NUMBER: 18-028-14 REV. D

THIS BULLETIN SUPERSEDES SERVICE BULLETIN 18-028-14 REV. C, DATED OCTOBER 10, 2014 WHICH SHOULD BE REMOVED FROM YOUR FILES. ALL REVISIONS ARE HIGHLIGHTED WITH **ASTERISKS**** AND INCLUDES ADDITIONAL SYSTEM ENHANCEMENTS, NEW RRT NUMBER WITH A NEW VIN LIST AND NEW LABOR OPS.**

Flash: MIL Illumination - Diagnostic and System Improvements

2014 (DS) Ram Pickup (1500)

Fig. 1 EGT Sensor Bank 1 Sensor 2

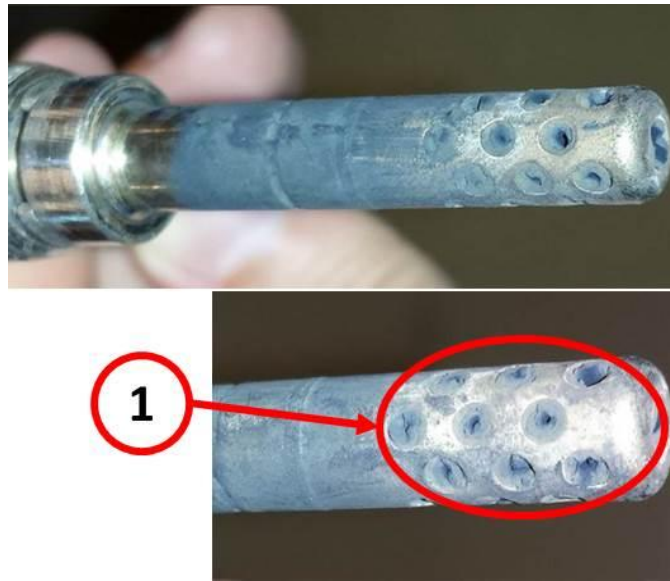
10. Replace the O2 sensor. Refer to detailed repair procedures available in DealerCONNECT> TechCONNECT> Service Info Section 14 - Fuel System> Fuel Injection, Diesel> Sensor, Oxygen> Removal/Installation. Proceed to [Step #11](#).
11. Remove the EGT Sensor 1/2 located in the inlet of the Diesel Particulate Filter (DPF)/Diesel Oxidation Catalyst (DOC) assembly. Refer to detailed removal procedures available in DealerCONNECT> TechCONNECT> Service Info Section 11 - Exhaust System> Sensor, Exhaust Temperature> Removal> Exhaust Gas Temperature Sensor 1/2.
12. Inspect the sensor body and probe for any signs of damage or excessive soot. Refer to ([Fig. 1](#)).

1 - Excessive soot blocking sensor ports.

-
13. Was excessive soot found on the sensor?
 - a. Yes>>> Proceed to [Step #14](#).
 - b. No>>> Proceed to [Step #15](#).
 14. Using shop air set to a maximum of 80 psi, clean all excessive soot from the sensor probe.
